CHANGES FROM SCHEME PERMITTED UNDER ABP-307415-20 - FIFTH FLOOR

PROPOSED FIFTH FLOOR

Project		RESIDENTIAL APARTMENTS, LISIEUX PARK		6-7 HARDCURT TERRACE, DUBLIN 2, IRELAND	
Drawing Title		Proposed Fifth Floor Plan		1+363-1-618 2100 1+363-1-678 7385	
Stage		Planning		www.bkd.ie	
Project Code		6275		bkdarchitects	
Job		LIS		BURKE-KENNEDY DOYLE	
Origin		BKD			
Zone		00			
Level		05			
Type		DR			
Dis		A			
Sheet no.		1100			
Status		P03			
Rev

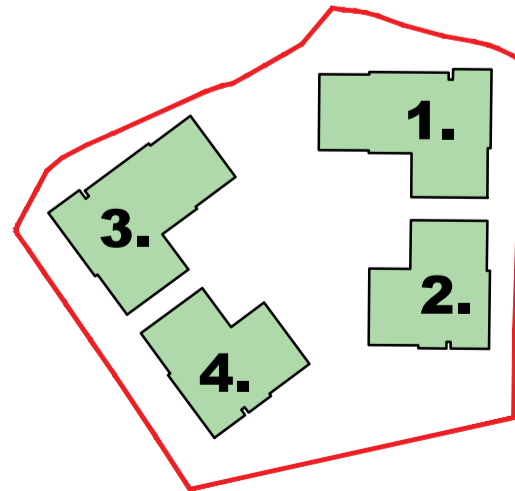
RECONFIGURATION OF LIFT/STAIR CORES TO COMPLY WITH DAC/FSC REQUIREMENTS.

EN-SUITES REMOVED FROM ALL 2 BED UNITS TO ALLOW SPACE FOR APARTMENT FRONT DOORS TO MOVE CLOSER TO THE PROTECTED CORES AND COMPLY WITH THE FSC.

CORRIDOR LENGTHS REDUCED AND DOORS MOVED CLOSER TO CORES TO ALL GABLE 2 BED UNITS TO SATISFY TRAVEL DISTANCES TO SUIT FSC.

ALL PERMITTED BEDROOM DOORS OPENING ON TO BALCONIES CHANGED TO WINDOWS TO IMPROVED SAFETY AND SECURITY.

BLOCK 2 & 4 ROOFS: 4 ADDITIONAL SMOKE CONTROL AOV'S AND LIFT OVERRUNS ADDED TO COMPLY WITH REQUIREMENTS OF FSC.

48 LOW-PITCH PV PANELS ADDED FOR COMPLIANCE WITH BUILDING REGS PART L

GLAZED ATRIUM REMOVED ABOVE STAIR AND LIFT CORE
